ROBINSON LANDING
Alexandria, VA

BUILDINGS 01 & 02
SUPPLEMENTAL SUBMISSION MATERIALS

OCTOBER 05, 2015

Based on continued feedback and input from Members of the Board of Architectural Review - Old and Historic District and from the Board's Staff, modifications to three elements of the submitted design are included herein:

PROFILE SECTION

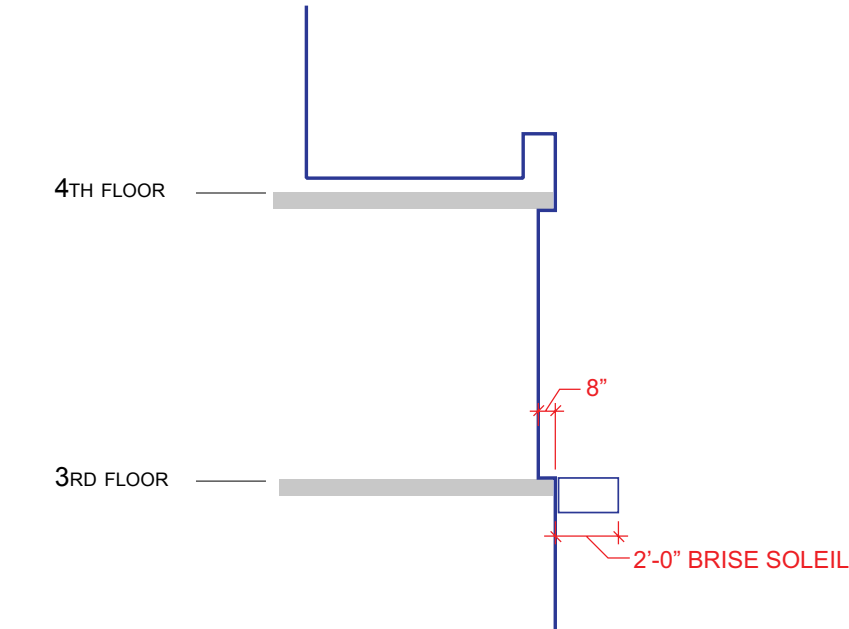
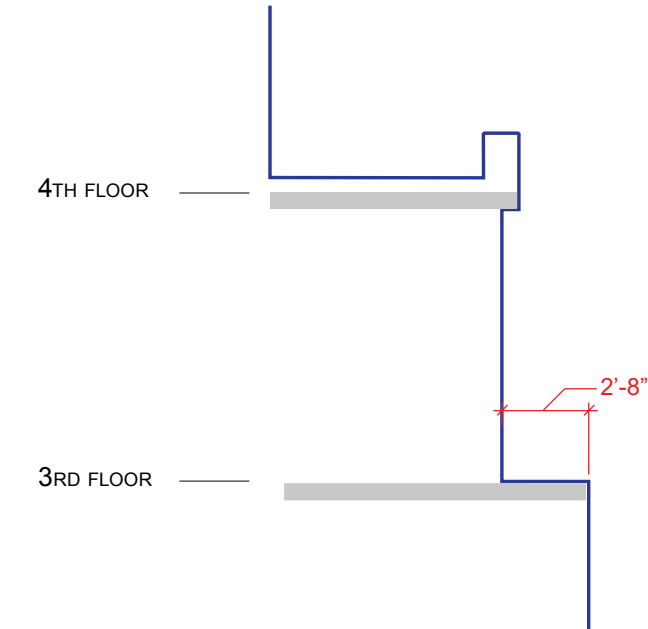
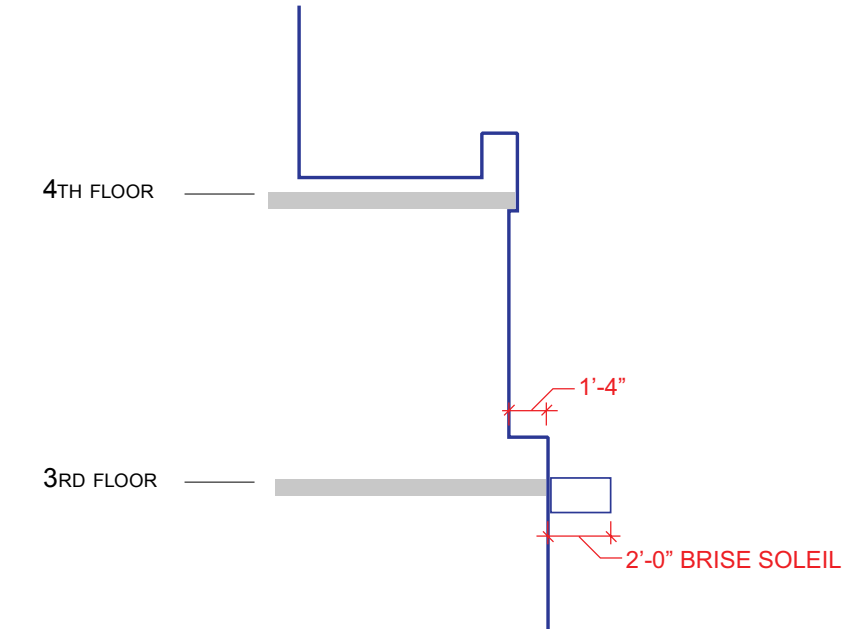
* CANOPIES SCREENING ROOFTOP MECHANICAL EQUIPEMENT WITH LOWERED HEIGHT AND REDUCED OVERHANG

* INCREASED SETBACK AT 30 FOOT HEIGHT

Designed as a cap or “brow” to screen mechanical equipment as viewed from the waterside, the submitted design shows a height of 4’-6” above the main roof level. Upon review and discussion of the ground-level views with Staff, these elements have been lowered 1’-6” to 3’-0” above roof level and their horizontal projection has been reduced approximately 2’-0” to balance the proportional relationship.

BUILDING 01 OVERALL ELEVATIONS - REVISED

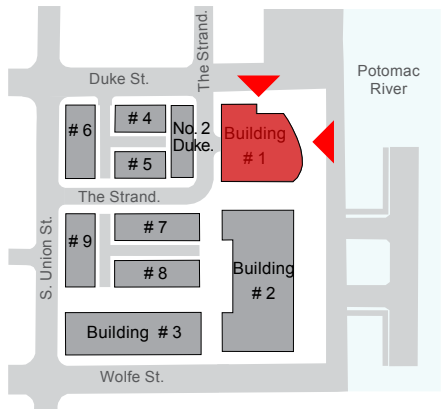
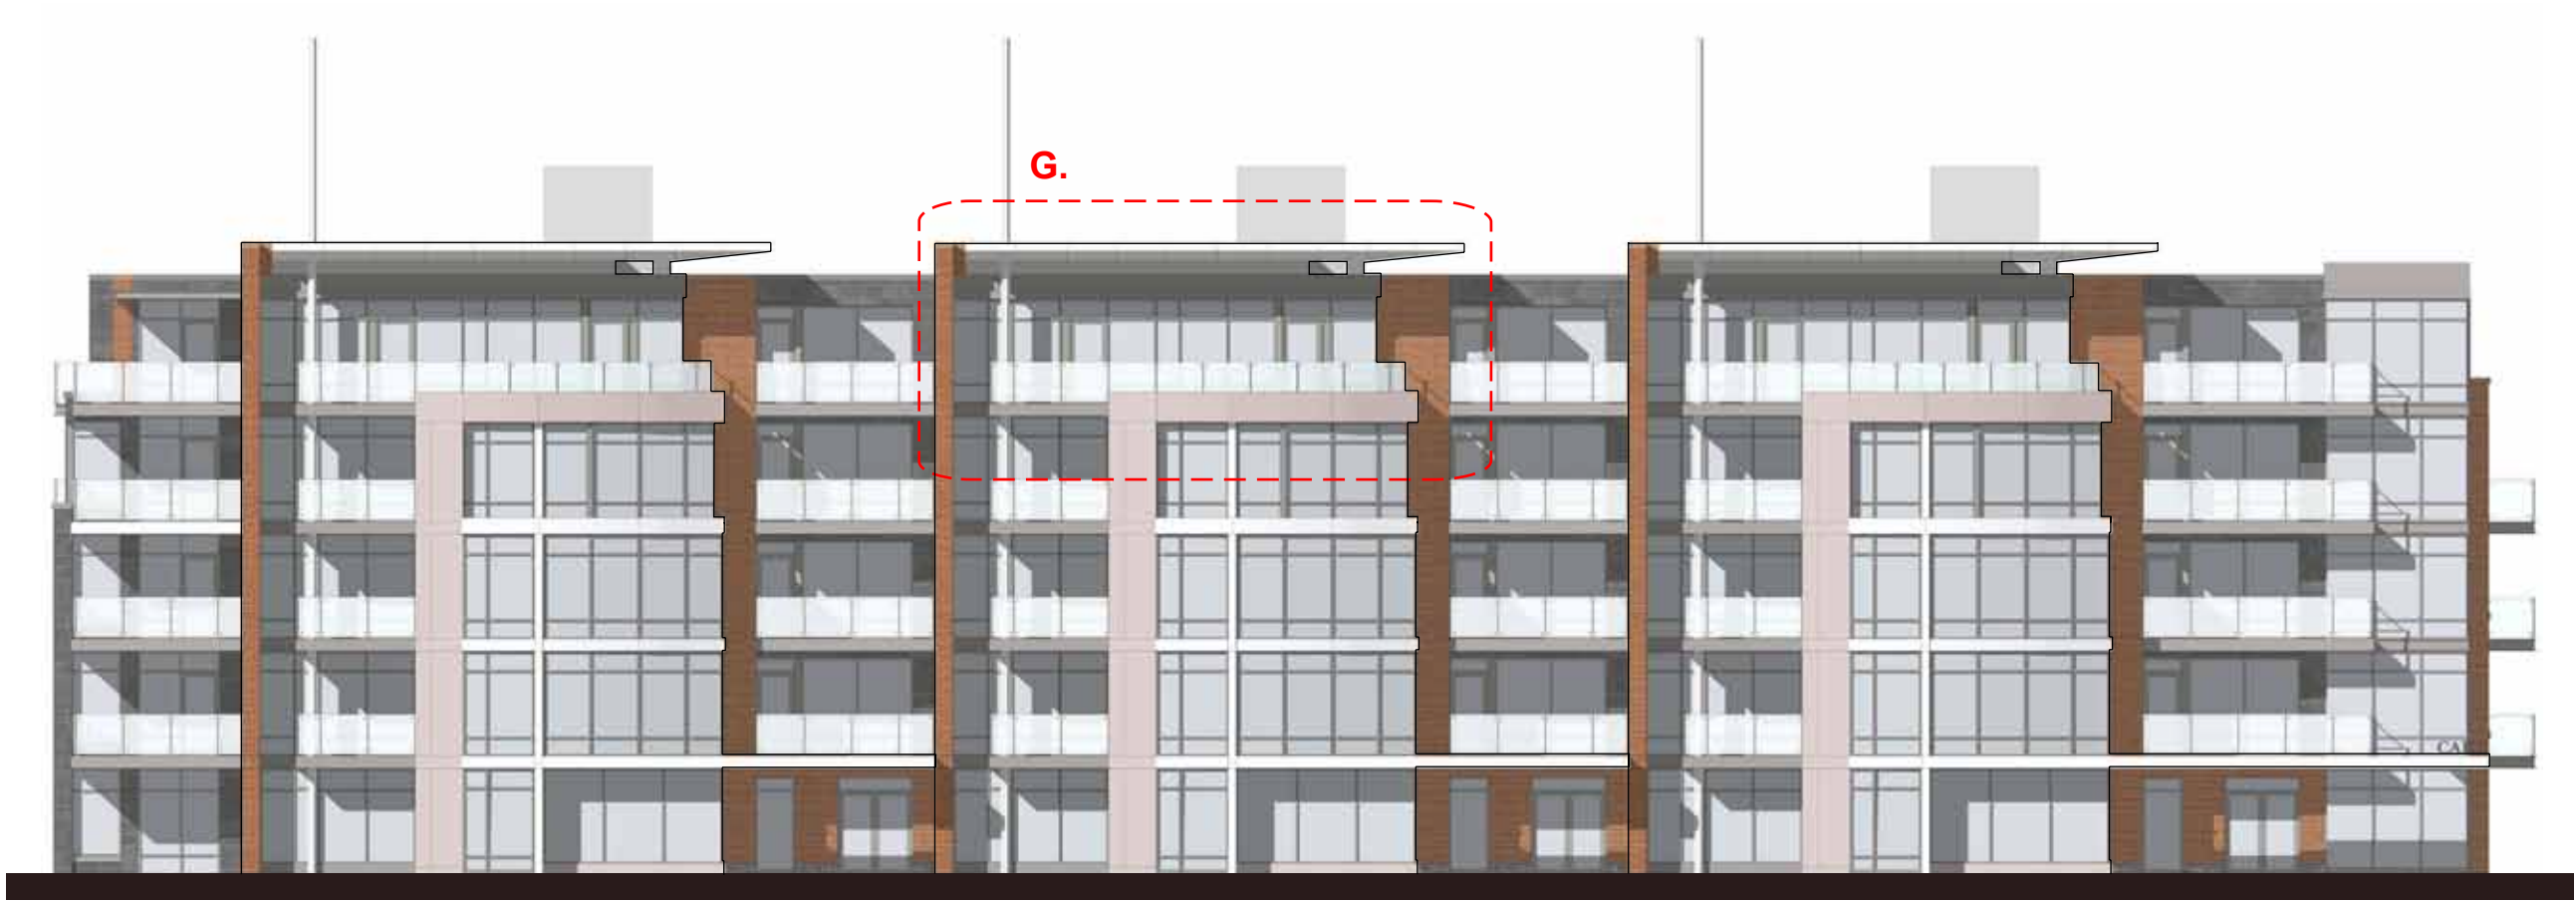
* CANOPIES SCREENING ROOFTOP MECHANICAL EQUIPEMENT WITH LOWERED HEIGHT AND REDUCED OVERHANG

* INCREASED SETBACK AT 30 FOOT HEIGHT

* CANOPIES SCREENING ROOFTOP MECHANICAL EQUIPEMENT WITH LOWERED HEIGHT AND REDUCED OVERHANG

* INCREASED SETBACK AT 30 FOOT HEIGHT

To further accentuate the 30’ line within the curved bay elements, a 2’-8” (+/-) setback at the fourth level and left “shoulder” has been introduced to create an additional three-story projecting glass bay. Within the glass bay, the horizontal metal bands at the floor lines are highlighted with the light accent metal color to accentuate the change in plane.

BUILDING 02 OVERALL ELEVATIONS - REVISED

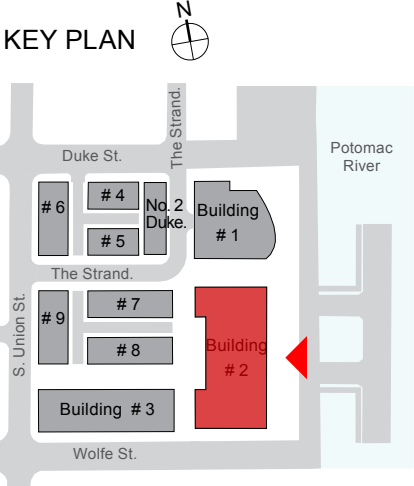
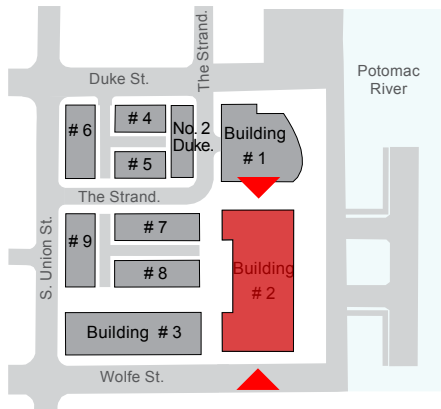
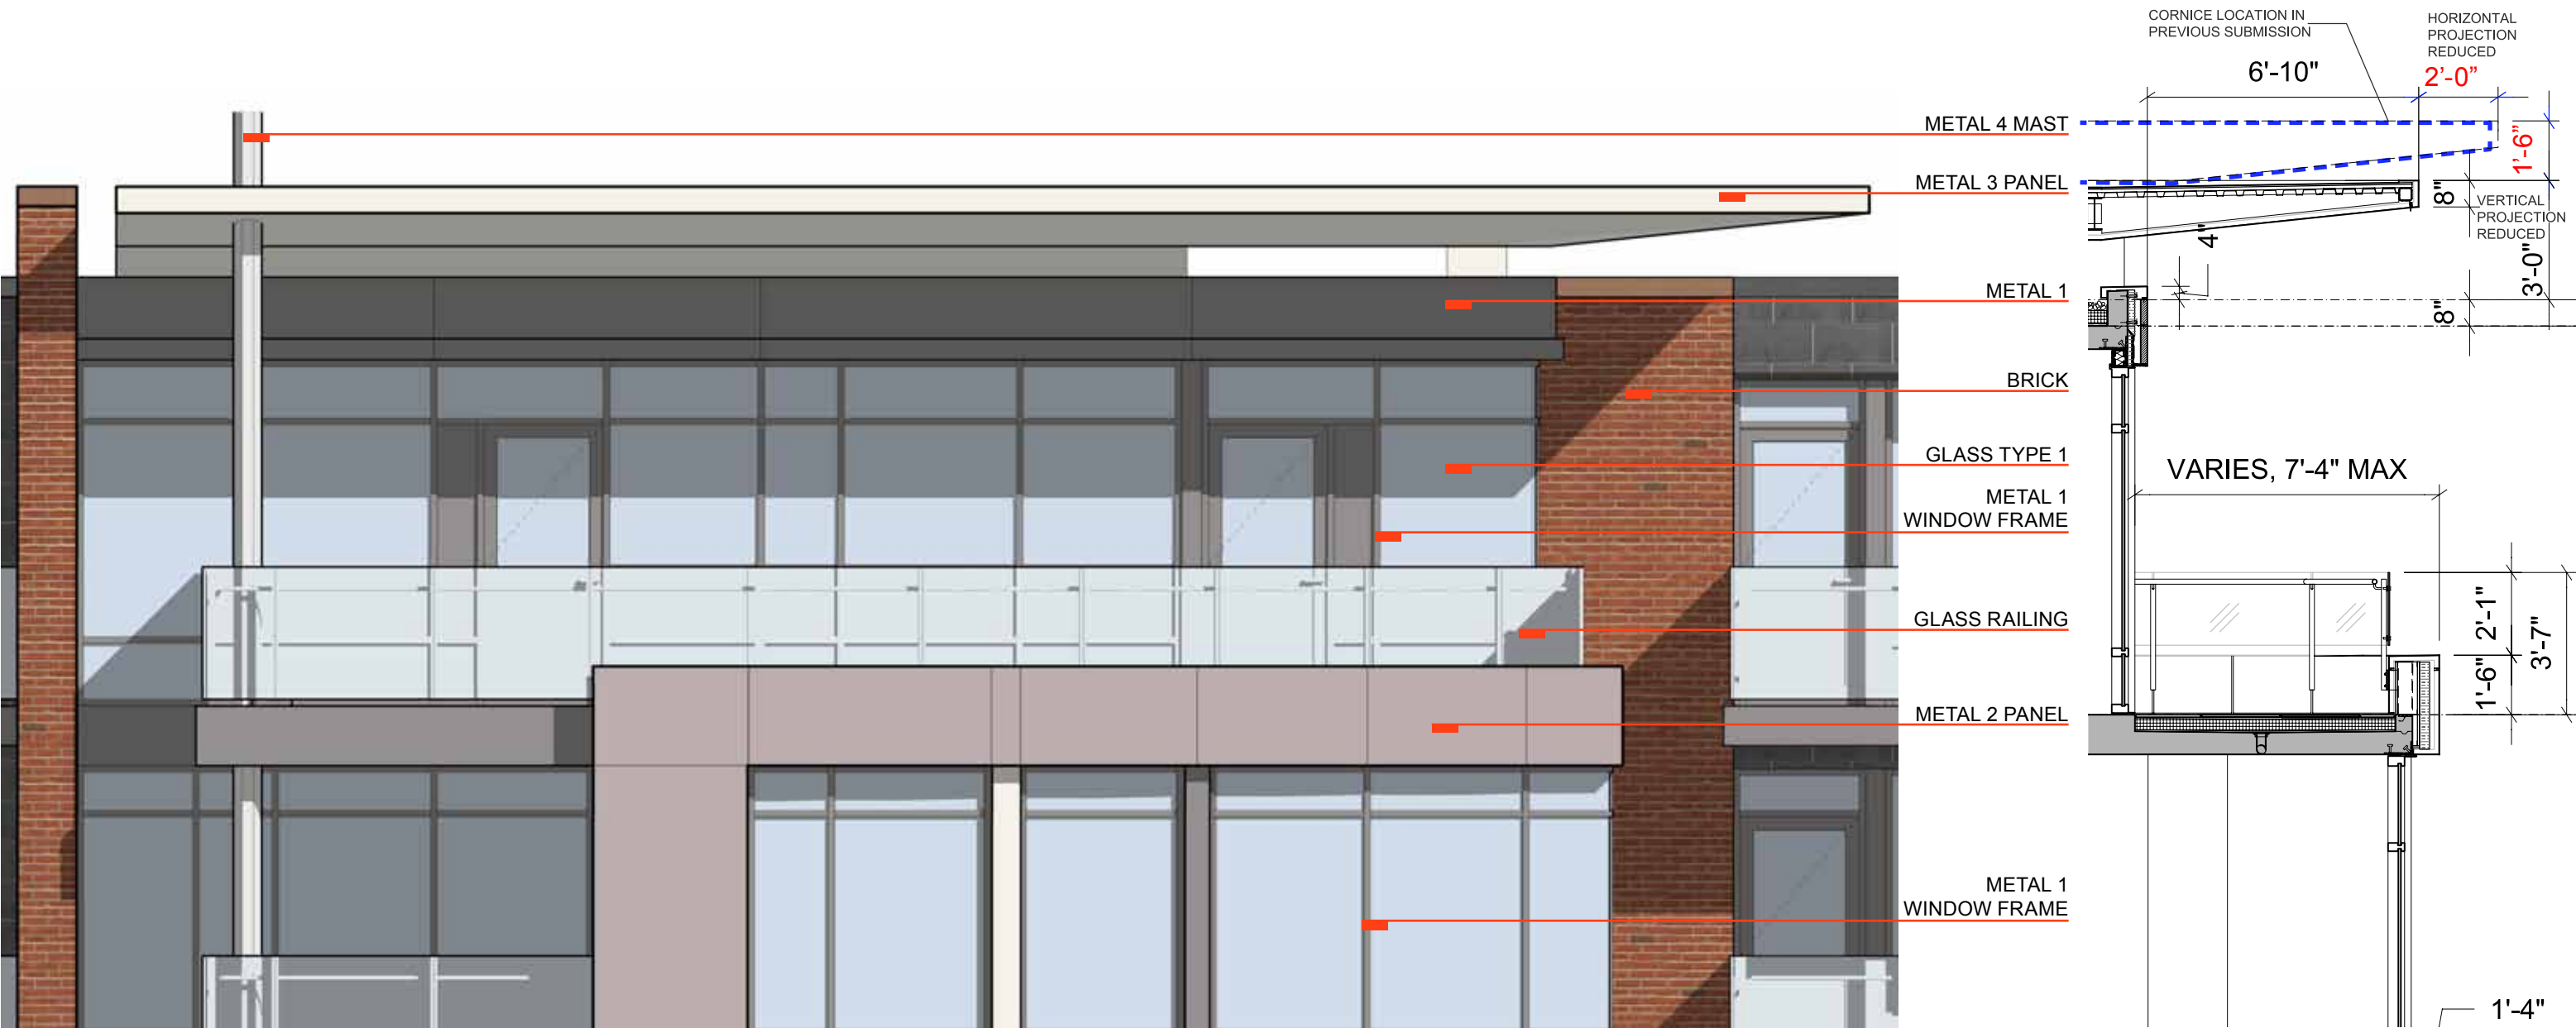
* CANOPIES SCREENING ROOFTOP MECHANICAL EQUIPEMENT WITH LOWERED HEIGHT AND REDUCED OVERHANG

* INCREASED SETBACK AT 30 FOOT HEIGHT

* INCREASED SETBACK AT 30 FOOT HEIGHT

* INCREASED SETBACK AT 30 FOOT HEIGHT

* INCREASED SETBACK AT 30 FOOT HEIGHT

The slate masonry at the fourth level of the horizontal bay projection has been set back approximately 1’-0” from the three floors below, and the depth at which the windows are inset at that level has been increased an additional 8”. Also, a projecting stone cap has been incorporated at the sill line of those windows. Similarly with the vertical bay at the west side, a projecting metal cap has been added at the sill line of the fourth level windows, and the windows of the fourth and fifth levels have been set back approximately 1’-2”.
